**Subject: Addendum to Work Plan for Subsurface Investigation
Former Exxon RAS #70691
10100 International Boulevard, Oakland, California
ACHCSA File No. RO0000162**

**Subject: Addendum to Work Plan for Subsurface Investigation
Former Exxon RAS #70691
10100 International Boulevard, Oakland, California
ACHCSA File No. RO0000162**

At the request of ExxonMobil Environmental Services Company on behalf of ExxonMobil Oil Corporation (ExxonMobil), ETIC Engineering, Inc. (ETIC) has prepared this Addendum to Work Plan for Subsurface Investigation (Addendum) for former Exxon Retail Site 70691, located at 10100 International Boulevard (formerly East 14th Street) in Oakland, California (Figures 1 and 2). This Addendum is being submitted in response to a letter from the Alameda County Health Care Services Agency (ACHCSA) dated 12 January 2012, an e-mail dated 13 January 2012, and a telephone conversation with the ACHCSA on 13 January 2012. Regulatory correspondence is included in Appendix A.

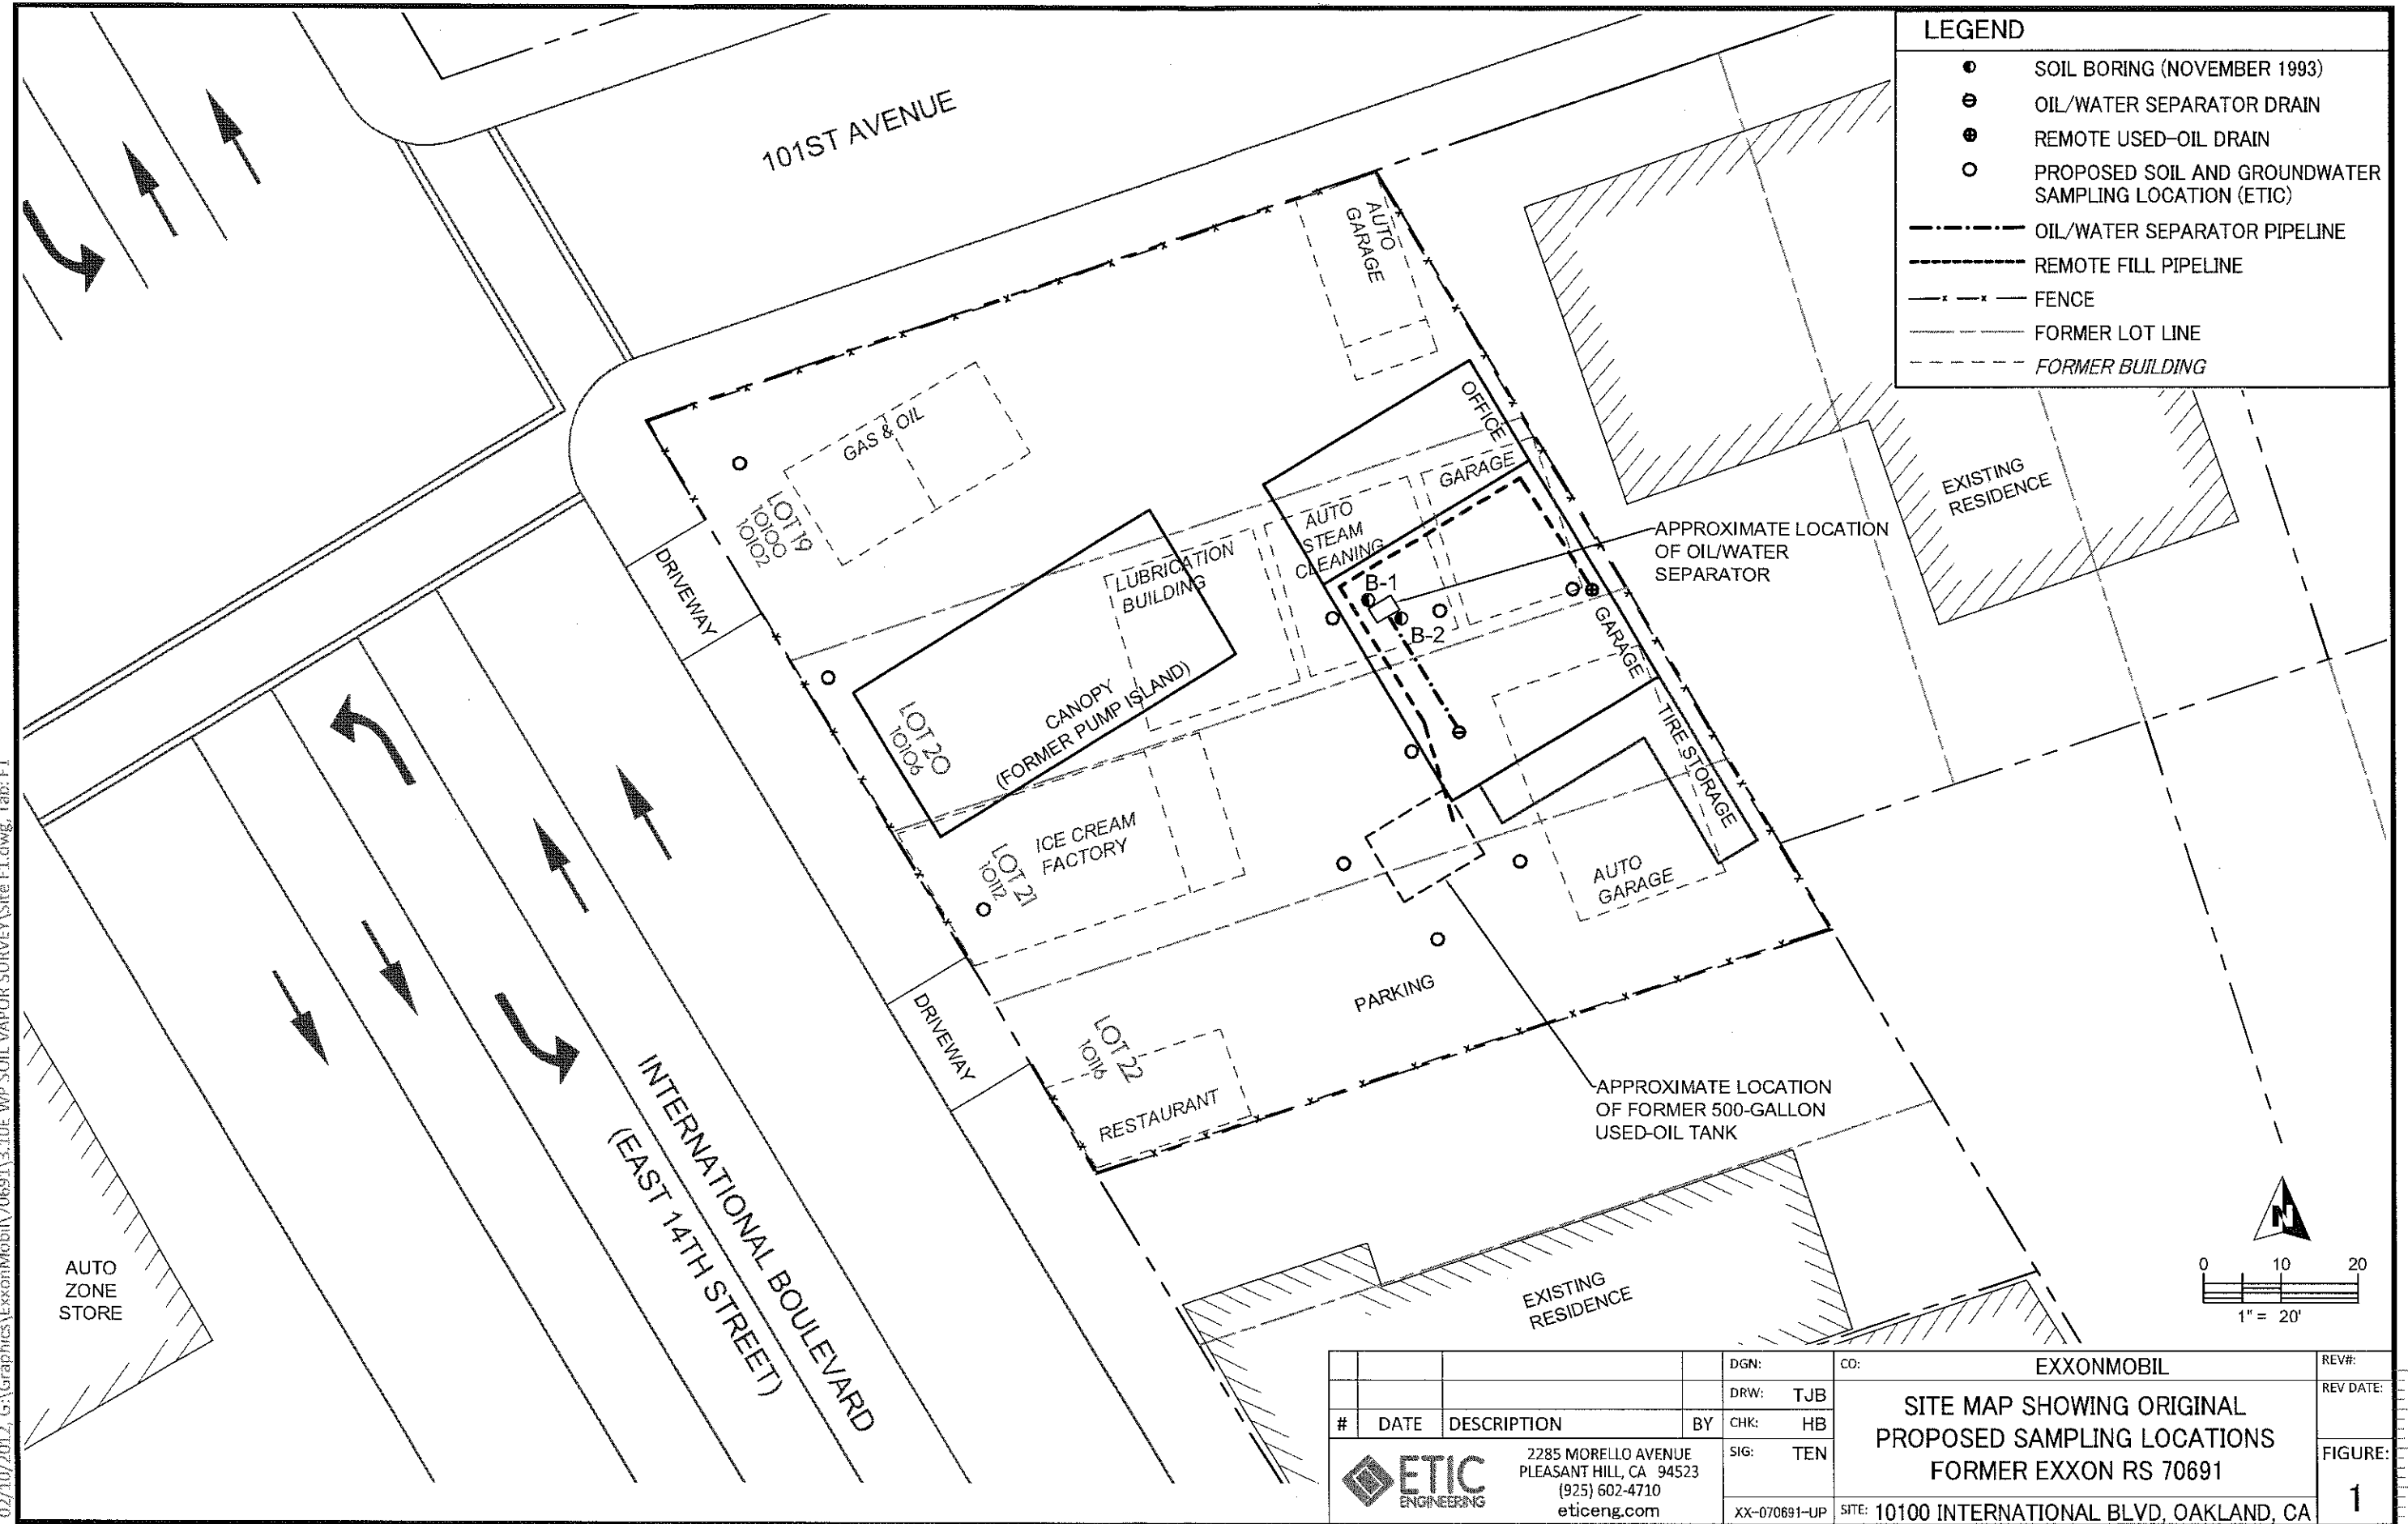
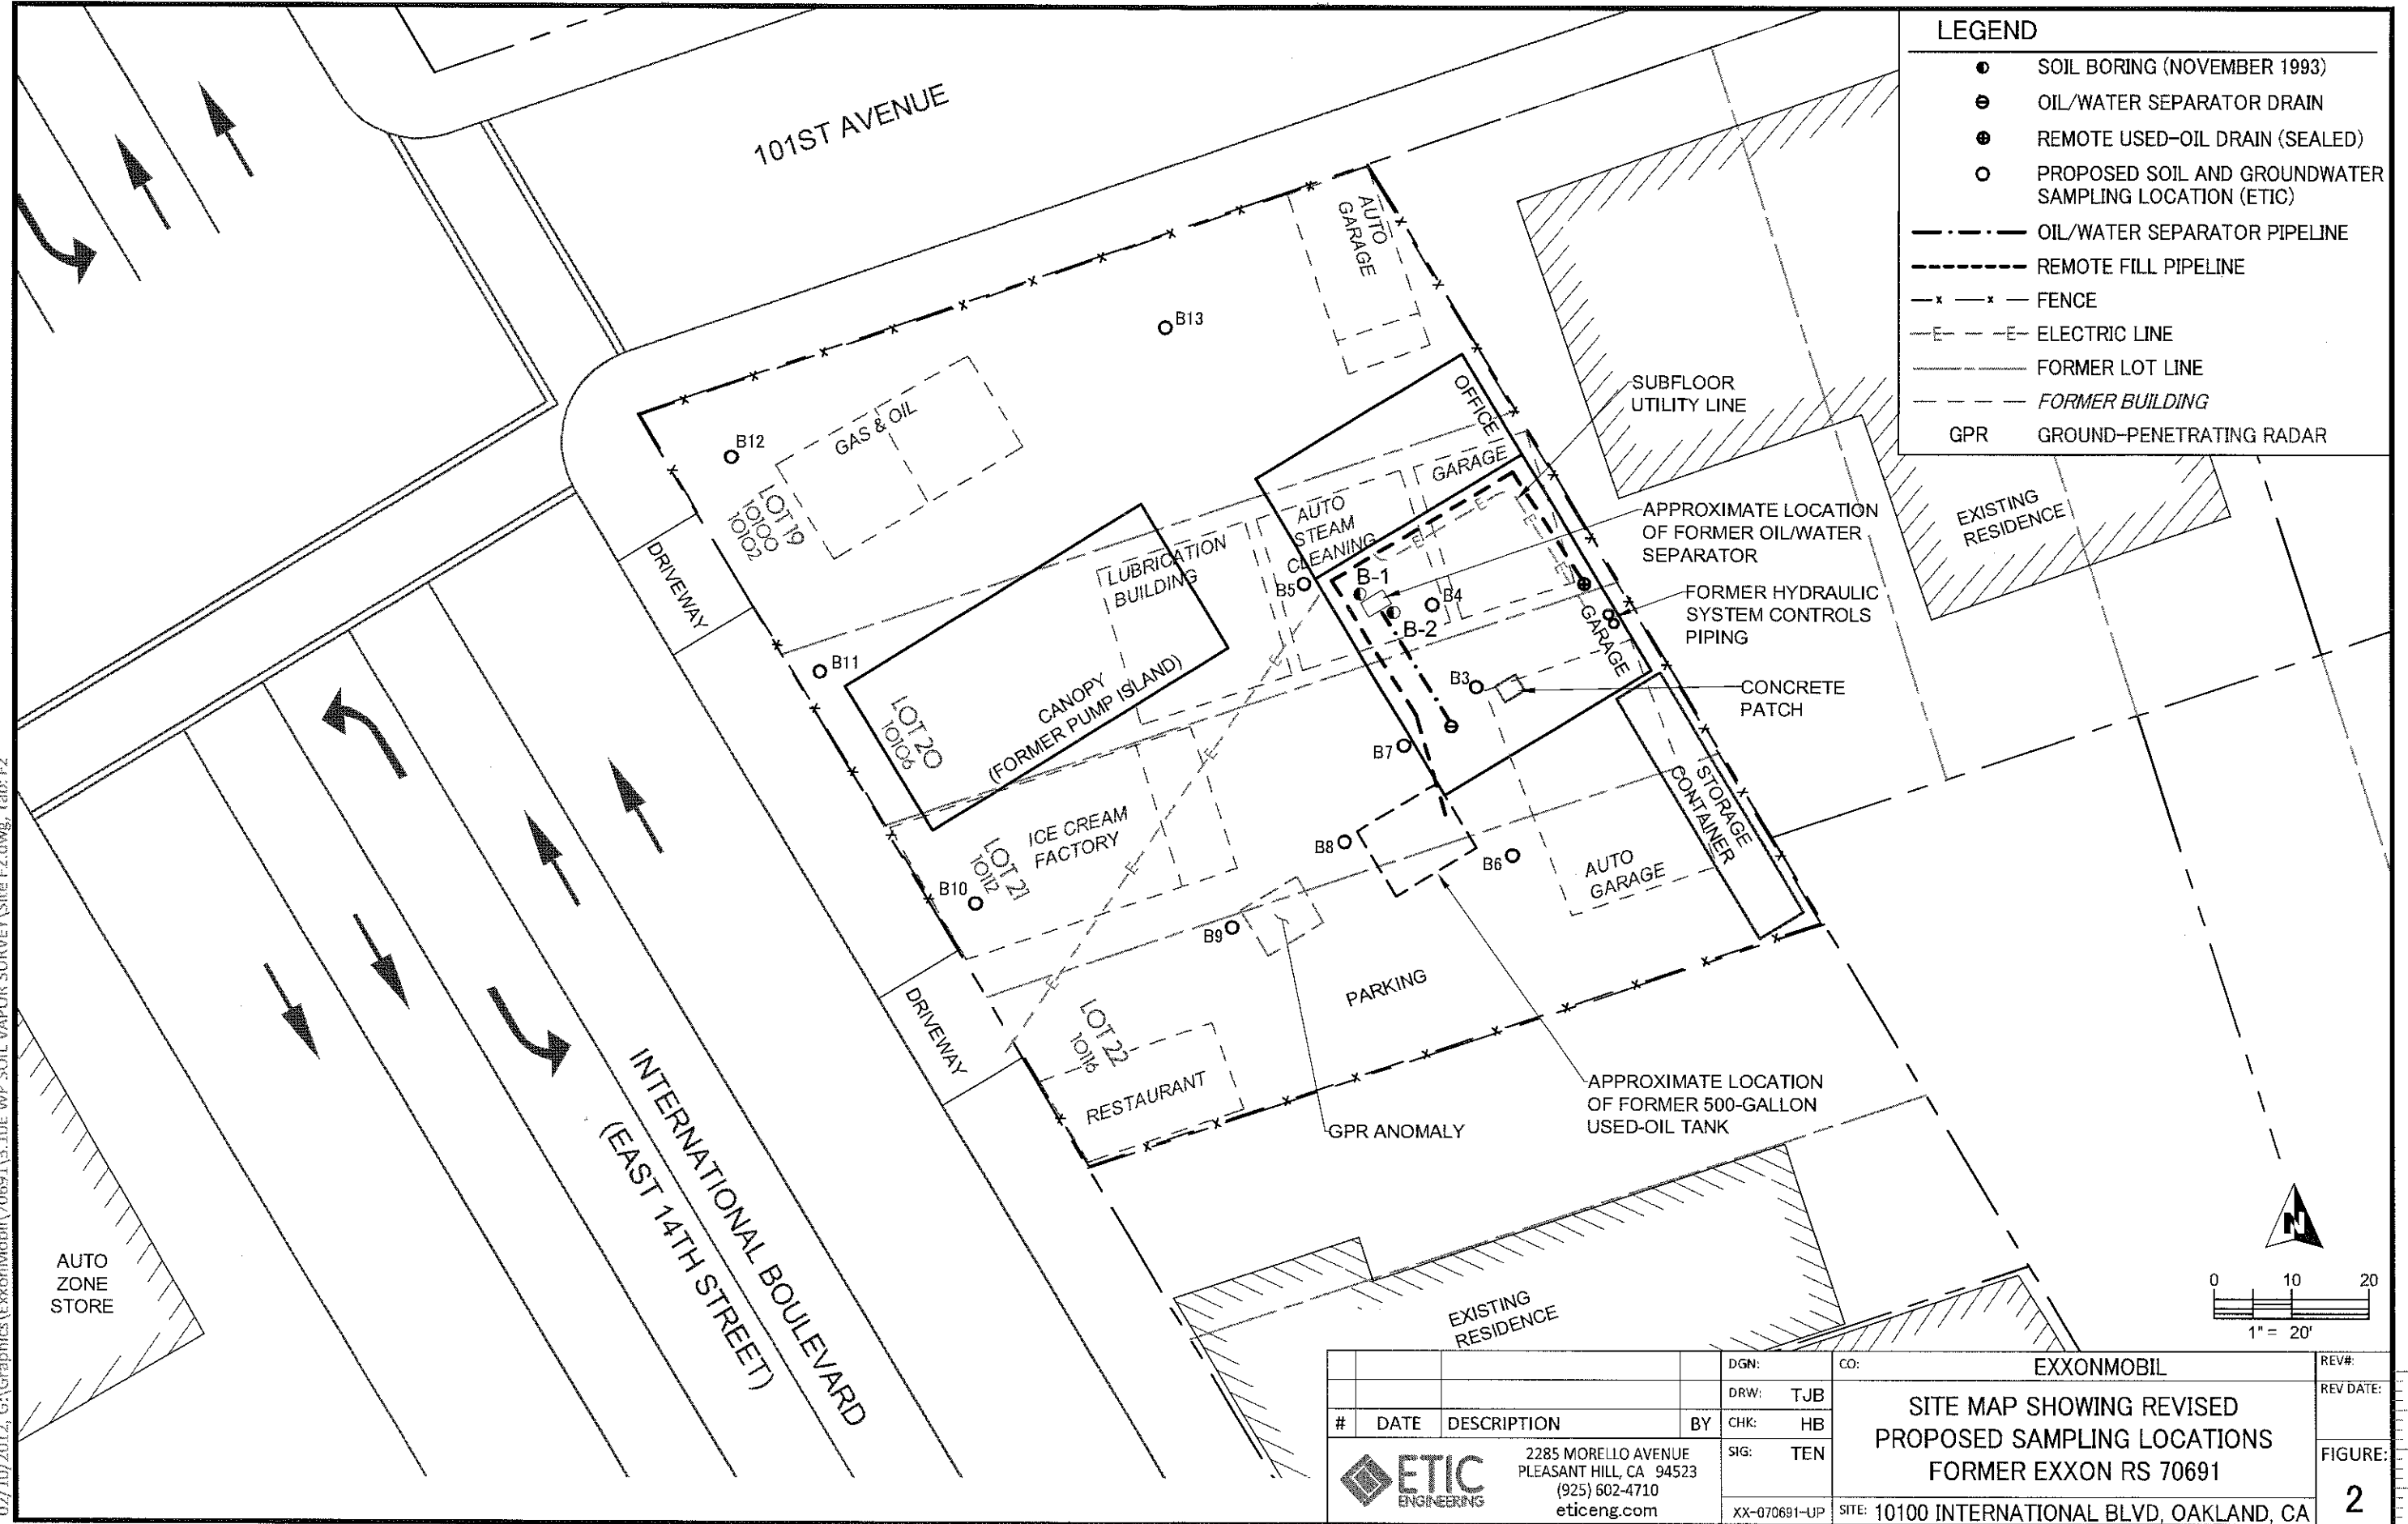
Based upon the preliminary results of the geophysical survey conducted in January 2012, two of the proposed soil and groundwater sampling locations were adjusted. Also, one additional soil boring is proposed to further characterize soil and groundwater quality at the site. Figure 1 illustrates the initial locations of the proposed soil borings (included in the work plan submitted in November 2011). The revised site plan (Figure 2) indicates the relocated soil borings (B3 and B9), and the additional proposed soil and groundwater sampling location (B13).

- Sampling location B3: Due to its close proximity to an underground utility (electrical line), the boring proposed adjacent to the sealed remote used-oil drain (Figure 1) was relocated (Figure 2) downgradient of a concrete patch in the garage bays (potential hydraulic lift excavation) identified during field activities performed in January 2012. Soil boring B4 remains downgradient of the sealed remote used-oil drain.
- Sampling location B9: The original proposed location of soil boring B9 was south of the former 500-gallon used-oil tank (Figure 1) and was relocated downgradient of the ground-penetrating radar anomaly identified during the geophysical survey (Figure 2).
- Sampling location B13: Soil boring B13 (Figure 2) was added to characterize soil and groundwater in the north-central portion of the site.
